The Secretary
NSW Department of Planning, Industry and Environment

I refer to the Department's below email of 18 November 2021 regarding the Environmental Impact Statement (EIS) for State Significant Development State Significant Development SSD-25452459 First Building Bradfield City Centre for 'Construction, fitout and use of the proposed First Building as an advanced manufacturing research and development facility, including site preparation works, site access and parking, utilities infrastructure and landscaping' at 215 Badgerys Creek Road, Bringelly (Lot 10 DP 1235662) in the Liverpool City Council Local Government Area (LGA). Submissions need to be made to the Department by 16 December 2021.

GROUND FLOOR PLAN

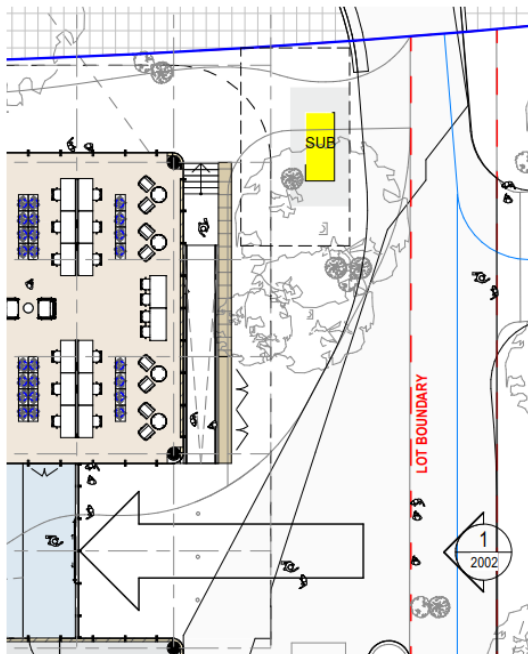
The Civil Design Report indicates a new padmount substation at property frontage within the First Building lot which is shown in the following extract of Appendix C (i) – Architectural Plans.

From Endeavour Energy's perspective the fact that provision is being made for a padmount substation is a positive. Endeavour Energy's general requirements is for a padmount substation to be at ground level and have direct access from a public street (unless provided with appropriate easements for the associated underground cables and right of access).

A4.3 - Padmount easements and clearances

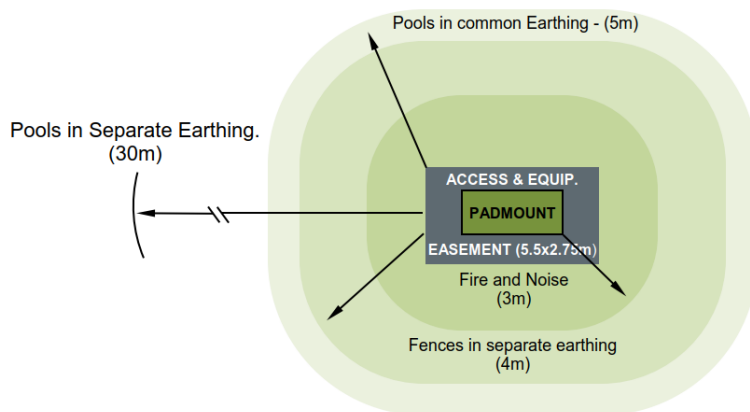
As shown in the following extract of Endeavour Energy's Mains Design Instruction MDI 0044 'Easements and Property Tenure Rights', Figure A4.3 'Padmount easements and clearances', padmount substations require:

- Easement with a minimum size of 2.75 x 5.5 metres (single transformer).
- Restriction for fire rating which usually extends 3 metres horizontally from the base of the substation footing / plinth and 6 metres vertically from the same point.
- Restriction for swimming pools which extends 5 metres from the easement.

The easement should not cross property boundaries but the restriction/s may affect any adjoining property provided they are able to be registered on the title to that property. In addition the following matters also need to be considered in regard to the fire restriction:

- Personnel access doors and fire exit doors to a building are not permitted within the fire restriction area.
- Gas mains/pipes shall not pass through the fire restriction area.
- A 10 metre clearance distance shall be maintained between substation and fire hydrants, booster valves, and the like in accordance with AS2419.1 'Fire hydrant installations System design, installation and commissioning' as updated from time to time.
- Any landscaping that potentially could transfer / provide connectivity for flame or radiant heat from a fire in the substation to a dwelling or building should be avoided.

- The storage of and / or use of flammable, combustible, corrosive or explosive material within the fire restriction should be avoided.
